**HYDRO-SEARCH, INC.**
A Tetra Tech Company

Kevin: Added revisions
as of 11-16-94 are in pencil
on pgs: 14, 18, 24, 25, 28
33, 34, 47

SOIL STABILIZATION/
SOLIDIFICATION
FINAL - INTERIM REMEDIAL MEASURES
REMEDIAL ACTION PLAN
PRESTOLITE PLANT
ARCADE, NEW YORK
11-17-94

November 17, 1994

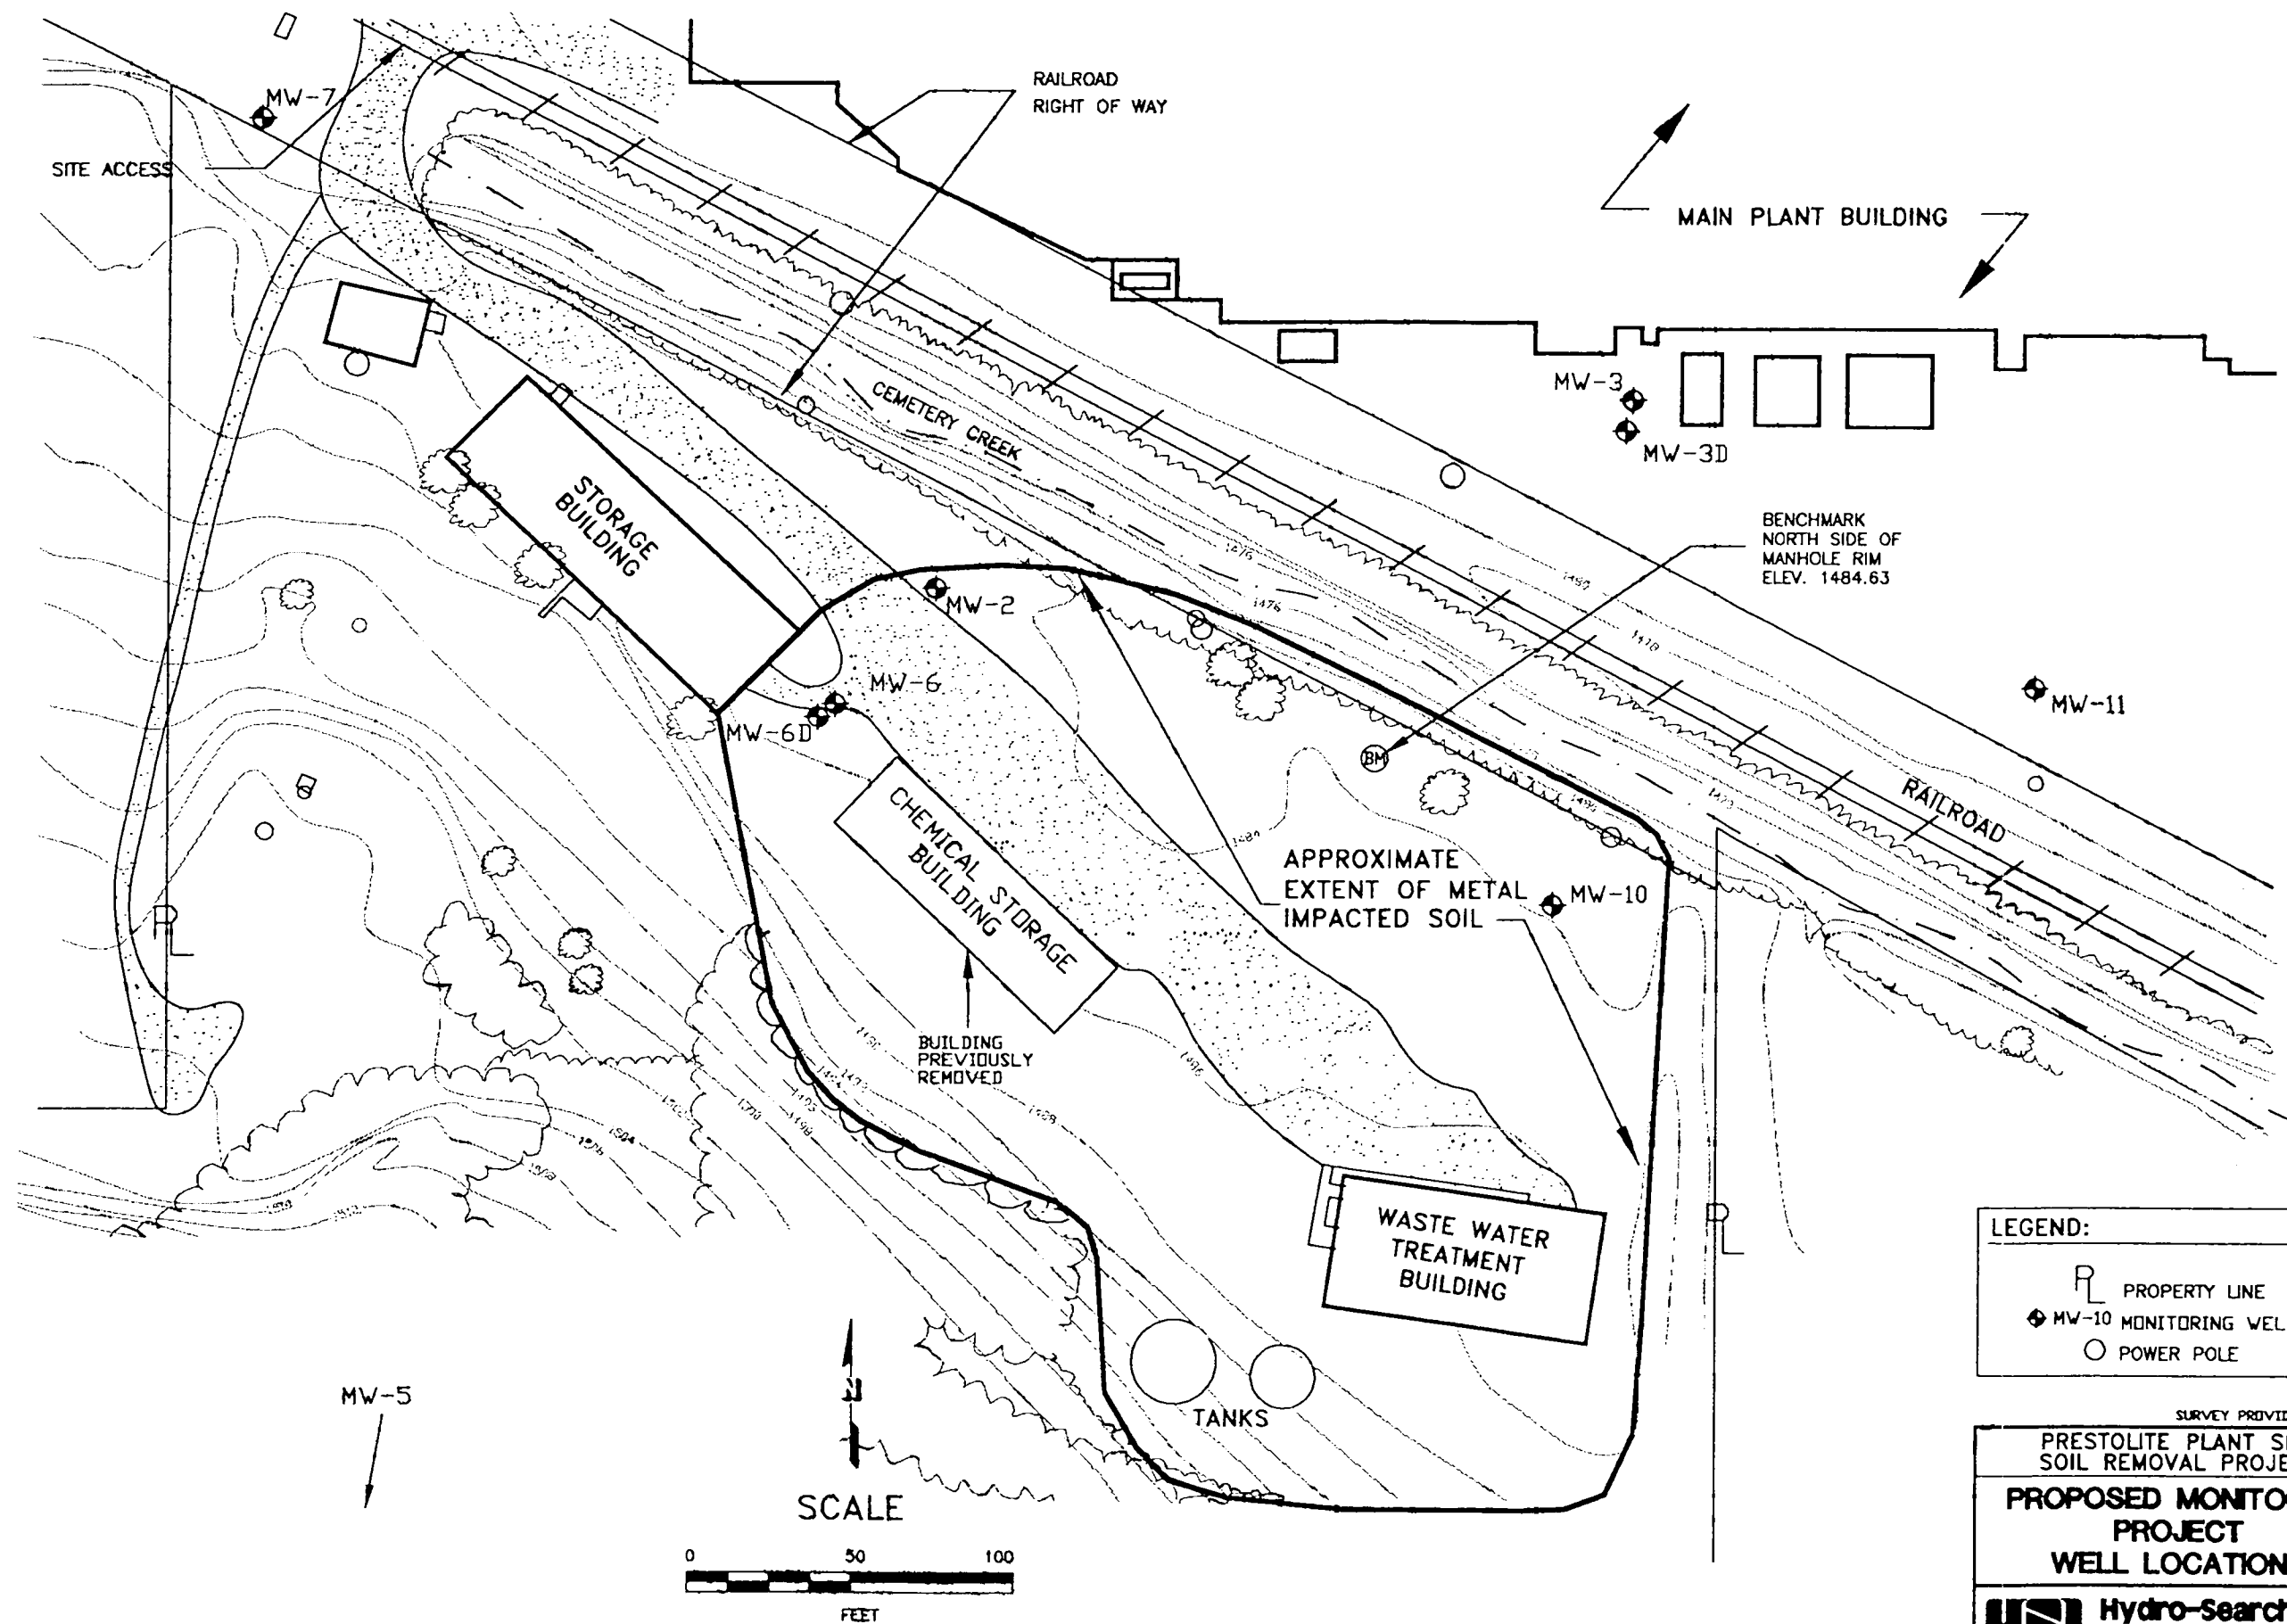
Fig 9-1
Table 9-2
